Access Compliance Report Public Rights-of-Way (Curb Ramps)

Main Street: PINEHURST_ST Cross Street: MEANDERING_TRAIL Location: SE

ADA ID: RPAT220208141301 Ramp Type: Type 1 - Perpendicular Diagonal Initial Pass/Fail: Fail Overall Compliance: No Severity Score: 16

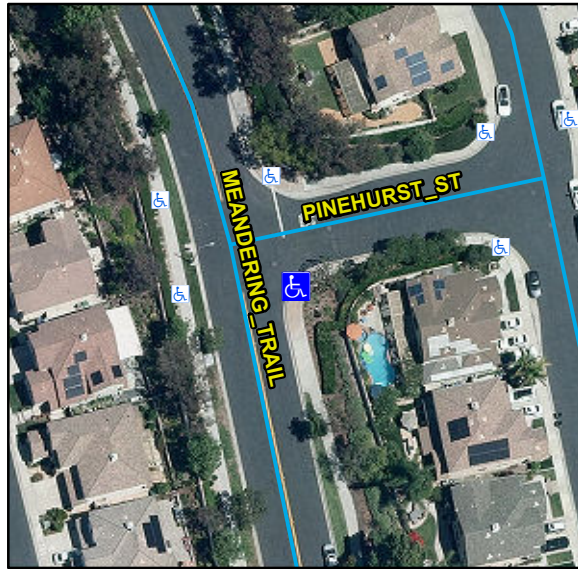
Compliance	Description	Data	Compliance	Description	Data
N/A	Ramp Length (in)	70	N/A	Flare Type LT	
Yes	Ramp Width (in)	58			N/A
No	Ramp Run Slope (%)	8.5	N/A	Flare Slope LT (%)	N/A
No	Ramp Cross Slope (%)	4.6	N/A	Flare Traversable LT	N/A
N/A	Landing Present	N/A	N/A	Flare Type RT	
N/A	Landing Length (in)	N/A			N/A
N/A	Landing Width (in)	N/A	N/A	Flare Slope RT (%)	N/A
N/A	Landing Run Slope (%)	N/A	N/A	Flare Traversable RT	N/A
N/A	Landing Cross Slope (%)	N/A	N/A	DWS Provided	N/A
N/A	Landing Movement Obstructed?	N/A	N/A	DWS Contrast	N/A
	Landing Movement Type	N/A	N/A	DWS Length (in)	N/A
N/A	Landing Shared	N/A	N/A	DWS Full Width	N/A
N/A	Clear Space	Yes	N/A	DWS Offset Left (in)	N/A
N/A	Clear Space To Crosswalk (in)	N/A	N/A	DWS Offset Right (in)	N/A
N/A	Marked Crosswalk 1	No	N/A	Marked Crosswalk 2	No
	Crossing 1 Direction	N		Crossing 2 Direction	W
	Marked Crosswalk 1 Width (in)	N/A		Marked Crosswalk 2 Width (in)	N/A

N/A	Ramp Inside Crosswalk 1	N/A	Yes	Ramp Inside Crosswalk 2	N/A
	Crossing 1 Slope (%)	7.9		Crossing 2 Slope (%)	3.2
	Crossing 1 Cross Slope (%)	5		Crossing 2 Cross Slope (%)	1.3
N/A	Gutter Ponding	N/A	No	Curb Slope	5.7
Yes	Gutter Lip Height (in)	0		Road Run Slope (%)	4.2
N/A	Gutter Run Slope (%)	N/A		Road Cross Slope (%)	1
N/A	Gutter Cross Slope (%)	N/A			
Yes	Overall Surface Condition: Acceptable		No	Perp Joint Present	No
	Cross Gutter Present?	No		Spandrel Present?	No
	Replace Cross Gutter?	N/A		Replace Spandrel?	N/A

Remove & Replace Curb Ramp With Two New Directional Ramps or Equivalent.
